ADDENDUM #3

The Gridley Sports Complex Ph 1

Project Number 24-02

December 2024

GRIDLEY SPORTS COMPLEX PH 1
WATERLINE DECOMMISSIONING PLAN
CITY OF GRIDLEY, CALIFORNIA

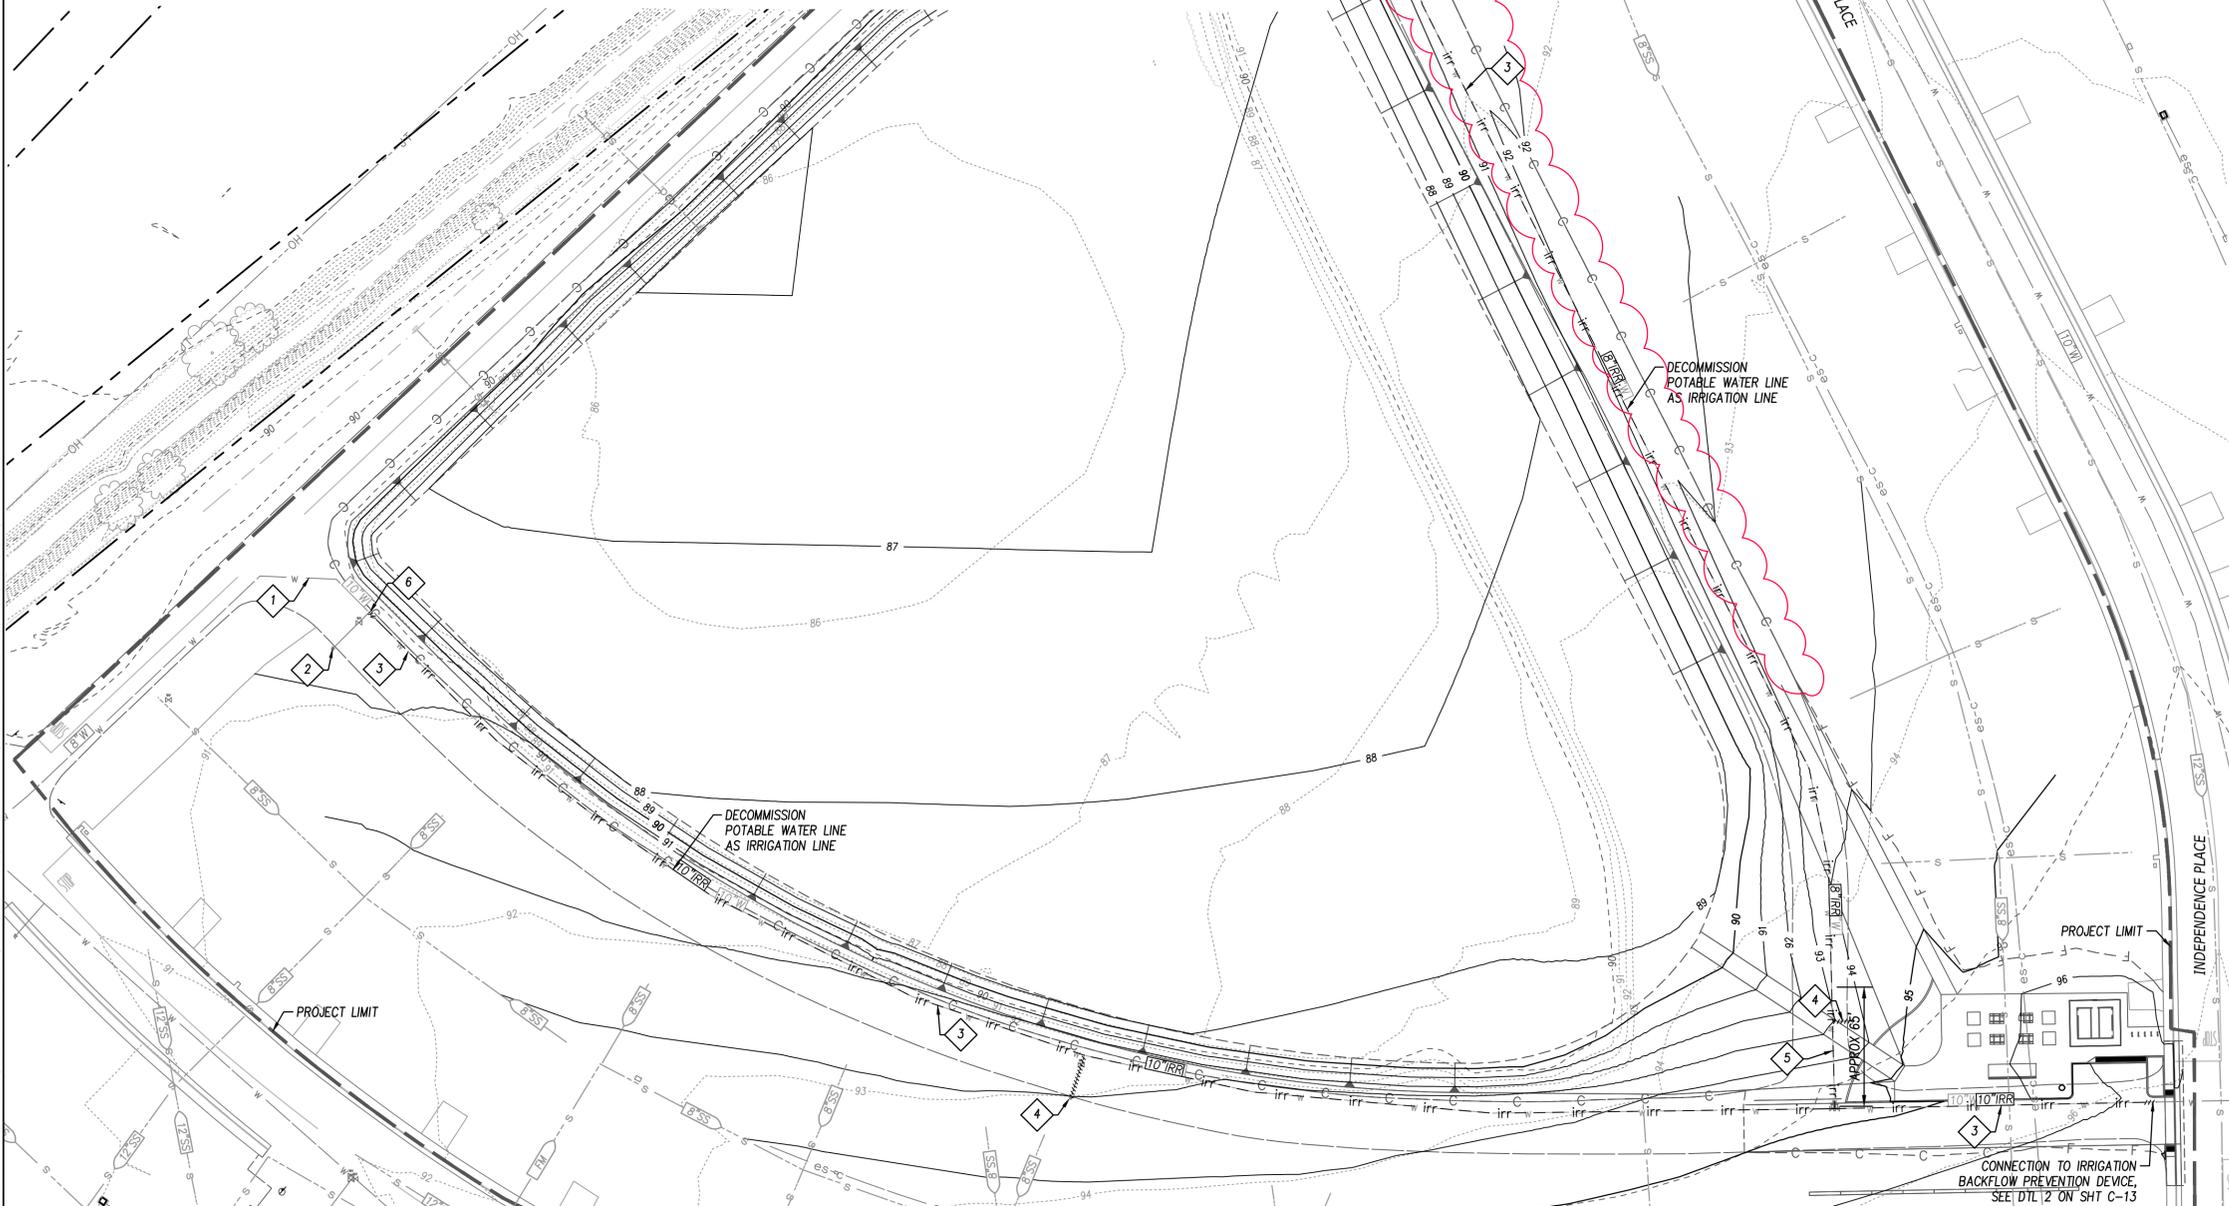
- 16. What is entailed in the lowering of the water main? How deep is it, and what is included in this bid item?
 - A. The contractor can assume that the waterline is approximately 36”-48” deep at this location. It will be on the contractor during staking and rough grading to determine the limits of the irrigation main that would not have sufficient cover after final grading activities are completed. That length of waterline will be confirmed with the project engineer (approximately 65’ in length per the plans) and lowered per Detail 1 Irrigation main lowering on Sheet C-2.

- WHEN WATER MAIN LOWERING IS PART OF A LARGER INSTALLATION, AND WHEN OTHERWISE PRACTICAL, THE NEW SYSTEM SHALL BE DESIGNED AS A "RESTRAINED JOINT SYSTEM", IN LIEU OF OR IN ADDITION TO ANCHOR BLOCKS, AND PER CITY STANDARDS. SEE CITY STANDARDS FOR ADDITIONAL INFORMATION AND REQUIREMENTS ON RESTRAINED JOINT SYSTEMS.

1 RIBBON DRAIN CONNECTION DETAIL
SCALE: NTS

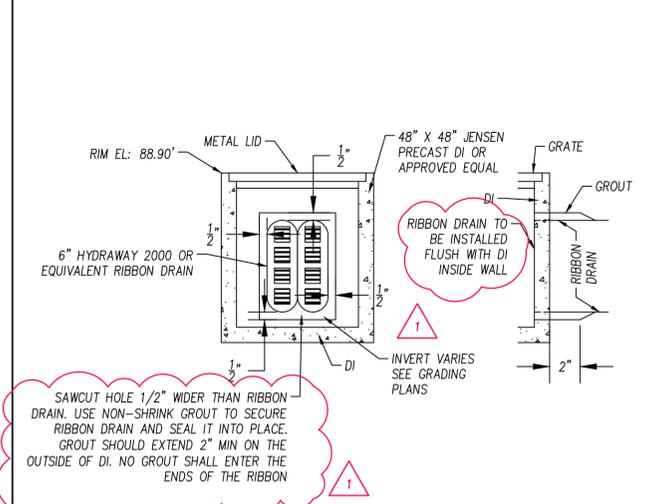
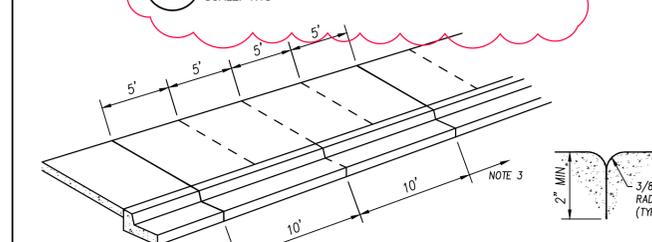
33. Bid Item #40 refers to 2-6" ribbon drains, however on the plan set there is no mention of where a ribbon drain is installed. Can we assume that the hydroway referred to on the plans is the same as the ribbon drain reference in the specs and bid item #40?
- A. Yes, the Hydroway on the plans is the same as Bid Item #40 2-6" Ribbon Drains. Ribbon Drain that is equal to Hydroway and meets the specification will be accepted. The Plans have been revised.

SAWCUT HOLE 1/2" WIDER THAN RIBBON DRAIN. USE NON-SHRINK GROUT TO SECURE RIBBON DRAIN AND SEAL IT INTO PLACE. GROUT SHOULD EXTEND 2" MIN ON THE OUTSIDE OF DI. NO GROUT SHALL ENTER THE ENDS OF THE RIBBON

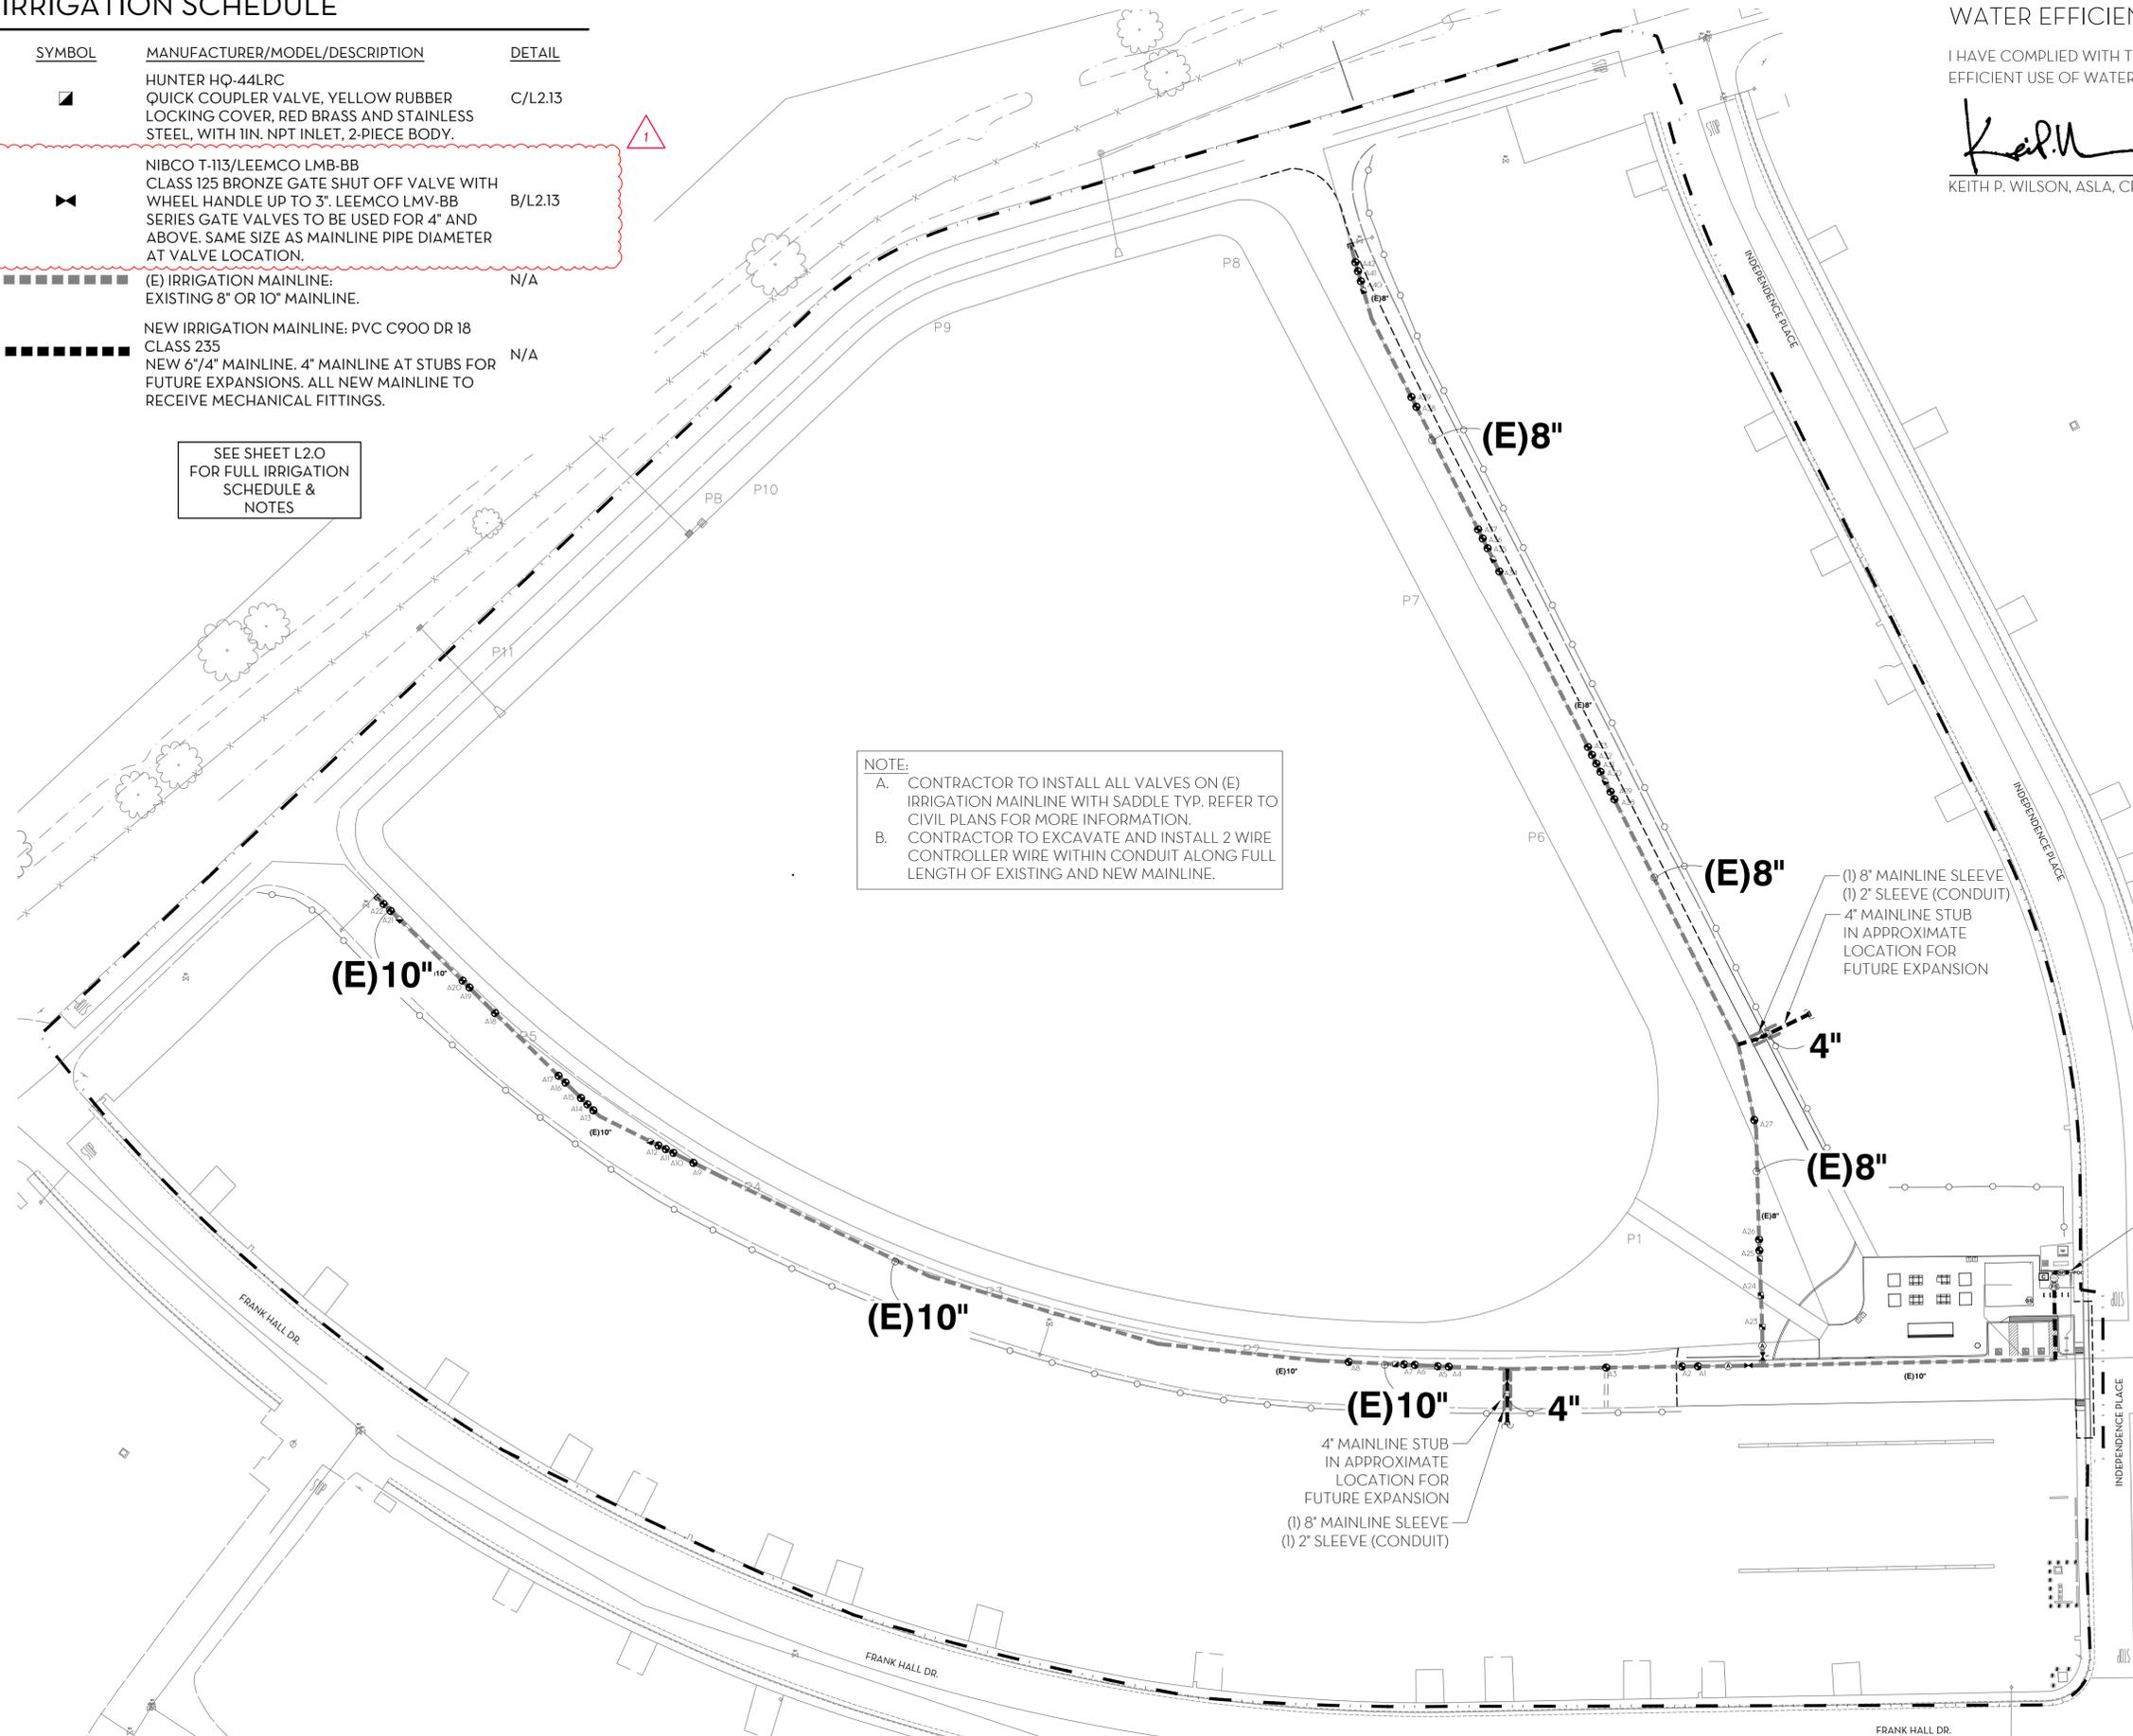
20. Gate valve model NIBCO T113 is only available for sizes 3" and smaller. Please provide a model of flanged gate valve for larger mainline size.
 - A. Contractor to utilize LEEMCO LMV-BB Series Gate Valves. Plan sheets have been revised.

1
PARTIAL ENLARGED SITE PLAN - ELECTRICAL
N

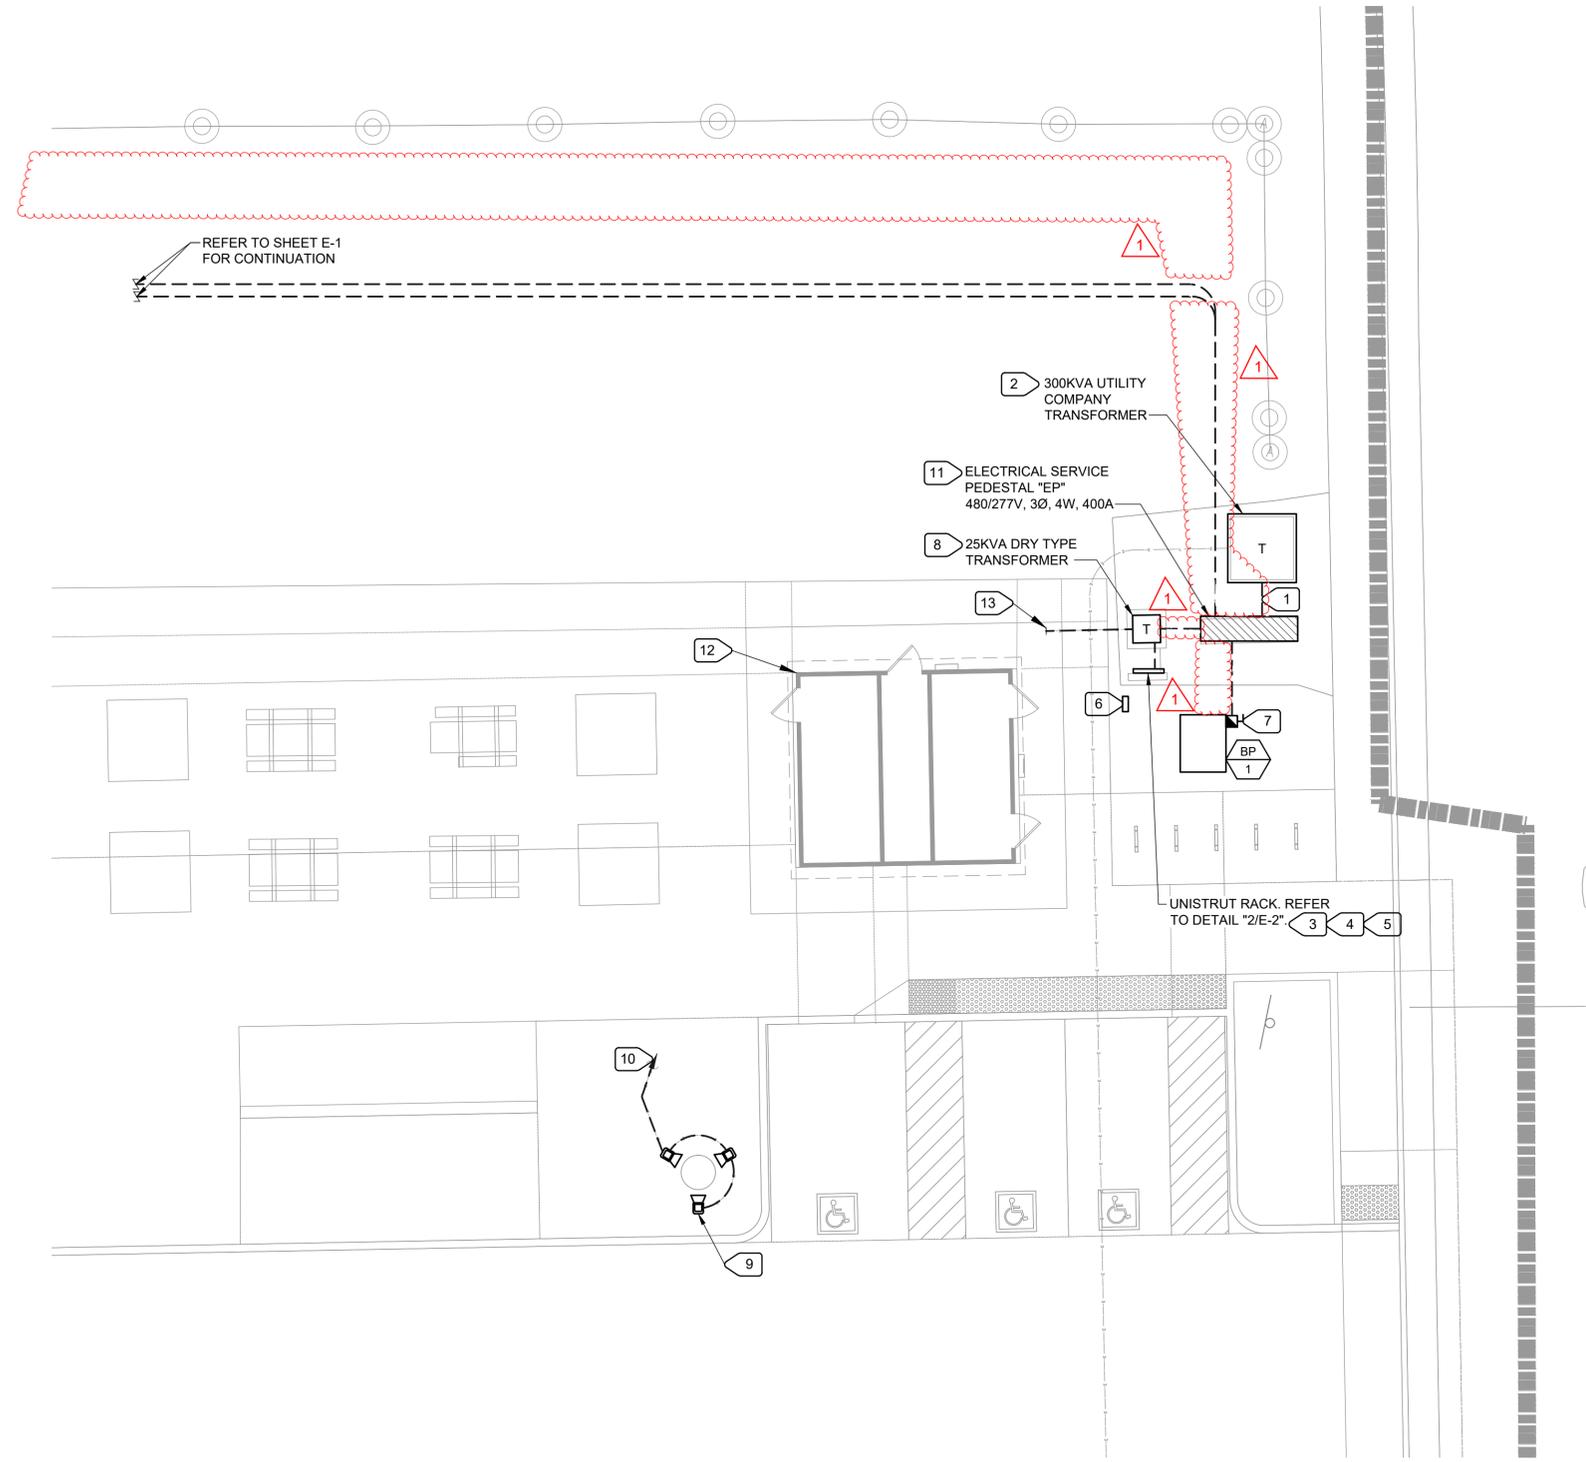
36. On Sheet E1.1, Shows existing electrical lines shaded (2) from the Tesco switchboard heading N then turning S, (1) from the Tesco switchboard to the 300KVA transformer, and (1) from the

- A. It appears that the conduits (----E----) shown are part of the site background. These are not existing electrical lines, see revised sheet E1.1.
 1. The conduit going south from the 300kVA transformer is the Utility company primary and will be provided by Gridley Electric.

2. The secondary conduits/conductors from the 300kVA transformer shall be installed by the contractor.
 3. Electrical contractor is to provide the 300KVA transformer pad.

4. All other conduits/conductors are to be provided by the electrical contractor. Refer to One Line Diagram. (Attached is a revised E1.1 for clarification.)

5. The Contractor shall be responsible for trench and backfill on all contractor installed conduits.
37. On Sheet E-1.1, numbered note 2. Provide the manufacturers model number for the precast 300KVA utility transformer pad. What are the requirements for preparation of the ground below the transformer pad prior to setting.
